Product Change Notification

Product Change Notification: E-18-004361

DEUTSCH DT2pin and 3pin Plug and Receptacles Product Drawings to add Weld Cap versions

Product Change Notification: E-17-010843

DT 2pin Weld Cap (Before)

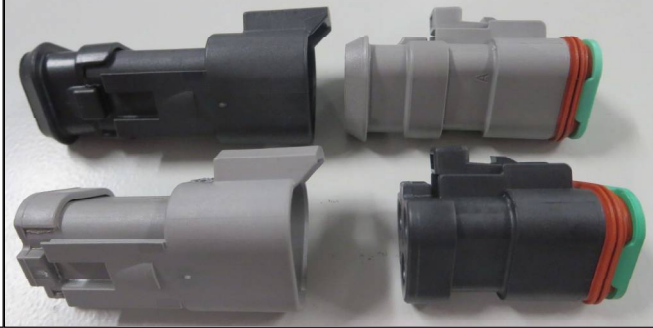
DEUTSCH DT2pin and 3pin Plug and Receptacles Global Footprint Initiative (Weld Cap)

The Industrial and Commercial Transportation (ICT) business unit of TE Connectivity (TEC) will be adding to existing North America (NA) based footprint for standard DEUTSCH DT 2pin and 3pin plug and receptacle connectors. Footprint additions are: TEC Suzhou (China) and TEC Empalme, SON (Mexico). Production location will be based on product type for connectors with or without rear caps. All manufacturing plants are ISO/TS 16949 certified. Also, part of this initiative will be some design changes. Plug front seals will use seal retention version, improved product marking and date coding. Legacy DEUTSCH part numbers remain same, PN revision change only, raw material-color remain same, interchangeable and backwards compatible. Box package will change to use standard automotive AIAG compliant box size. See attached presentation and product drawings for more information.
